INCH-POUND
MIL-F-24724/2(SH)
AMENDMENT 1
2 June 1992

MILITARY SPECIFICATION SHEET

FILTER HOUSINGS (HYDRAULIC) AND DIFFERENTIAL PRESSURE INDICATOR
(4 AND 6 ELEMENTS)

This amendment forms a part of MIL-F-24724/2(SH), dated 15 February 1990, and is approved for use by the Naval Sea Systems Command, Department of the Navy and is available for use by all Departments and Agencies of the Department of Defense.

FIGURE 1. Filter housing.

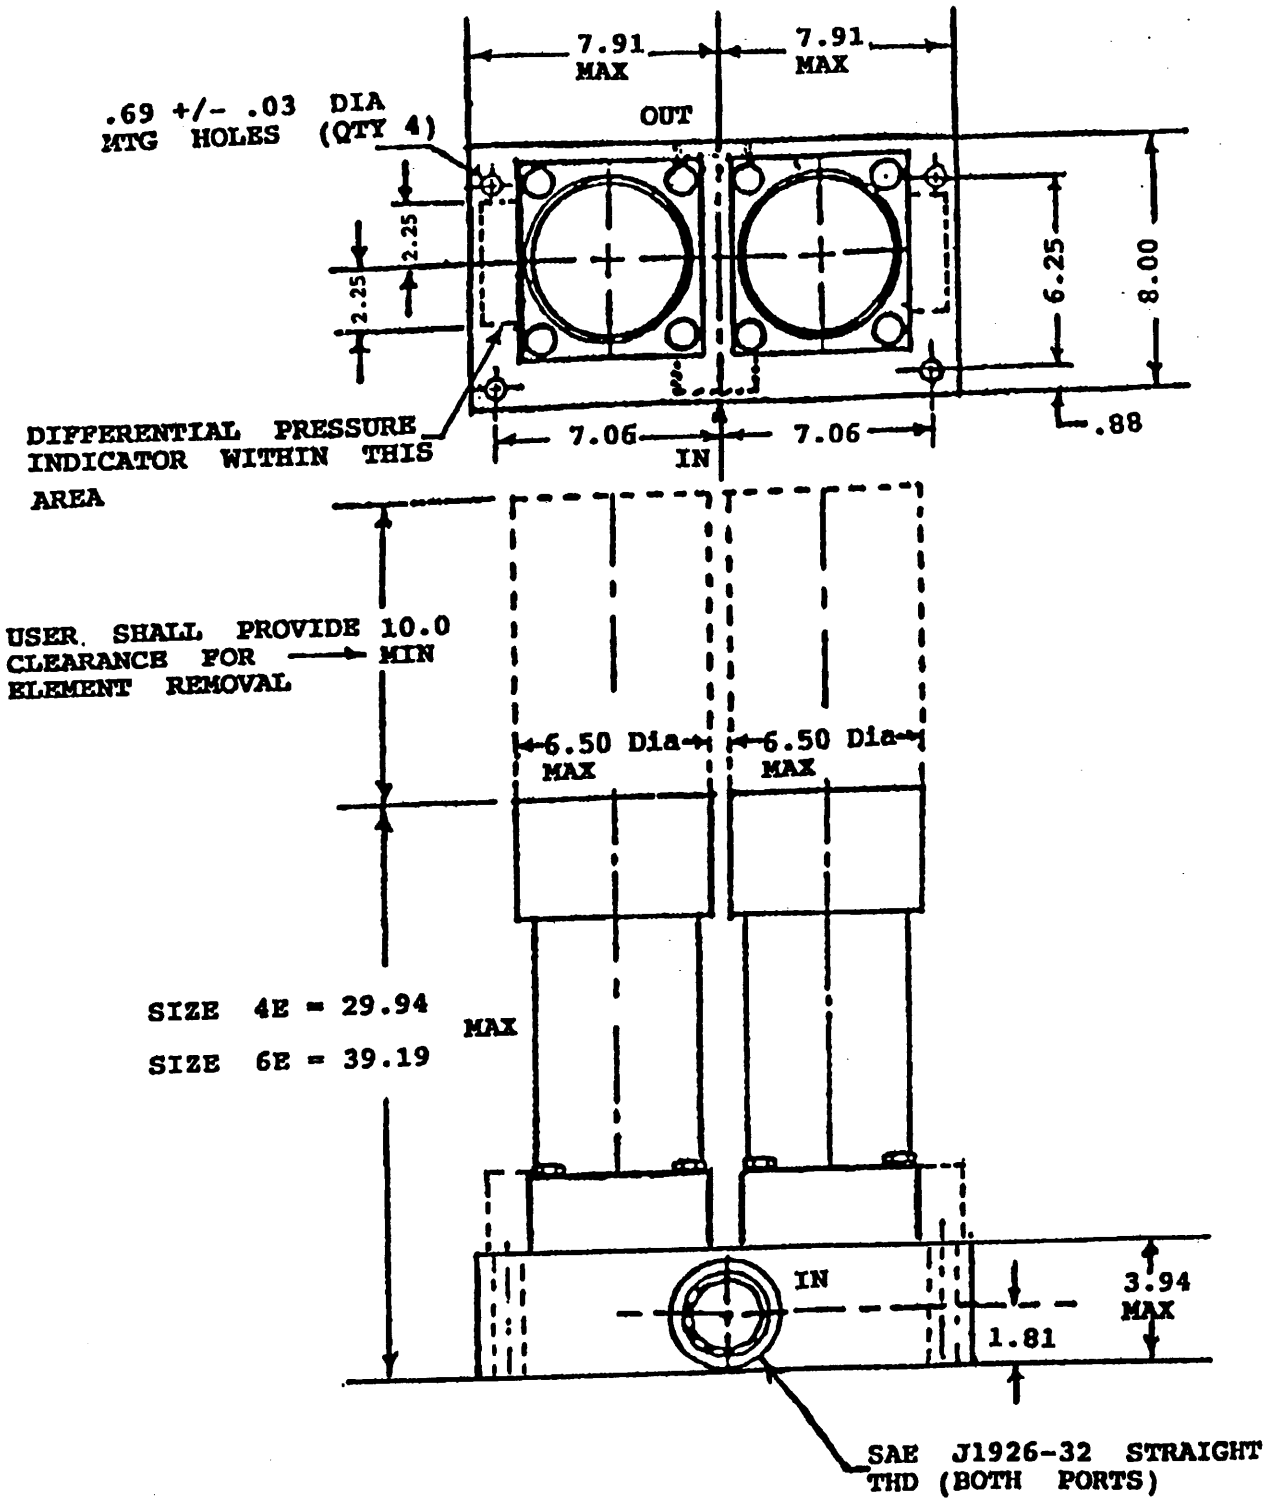
FIGURE 1: Delete and substitute the attached.

Under "NOTES", item 5: Delete "be 7.50 inches maximum." and substitute "not exceed 10.0 inches".
